**City of Gainesville  
Department of Community Development  
Current Planning Division  
Summary of Technical Review Committee Comments**

**Petition:** 22SUB-06DB

**Project Name/Description:** Design Plat review for 10 lots on 1.16 acres MOL. Ingleside Village Subdivision. Located between Northwest 17<sup>th</sup> Avenue and Northwest 18<sup>th</sup> Avenue and between Northwest 9<sup>th</sup> Street and Northwest 10<sup>th</sup> Street. Brown & Cullen, Inc., agent for Andrew Kaplan.

# DESIGN PLAT of INGLESIDE VILLAGE

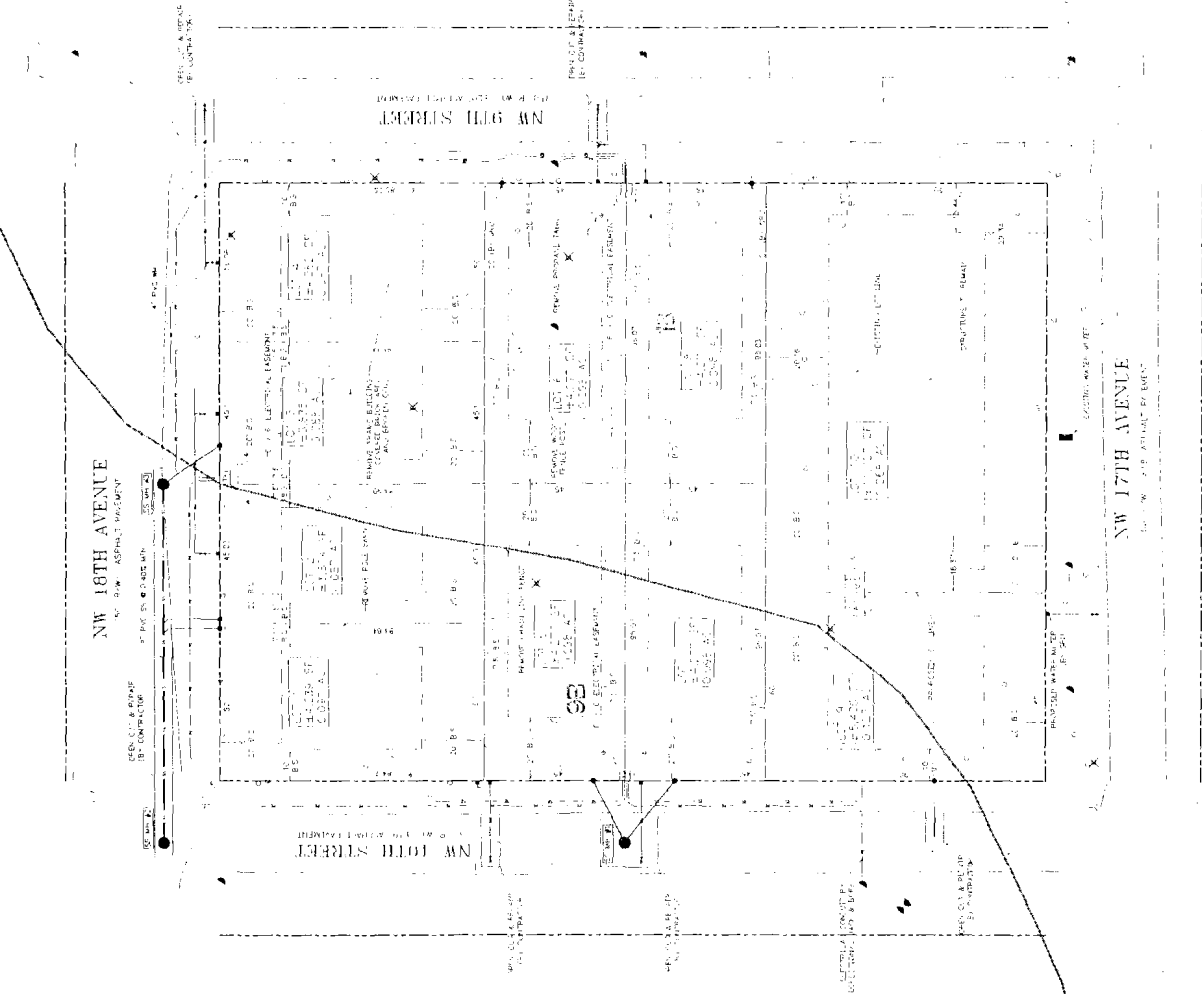
1. Sidewalks at least five feet in width are required on all streets abutting the subject property. City Commission approval must be granted to exempt the applicant from this sidewalk requirement.
2. The sheet number shall be provided on the Topographic and Tree Survey, and the name of the survey shall be corrected in the legend on Sheet 1.
3. The design plat shall note that concrete areas beneath pole barn will be removed.

1. The utility connections proposed within City right-of-way must be inspected by Public Works construction Inspectors.
2. Please identify the soils delineation line on the legend for the design plat. Can the line be shown with a thinner weight line?
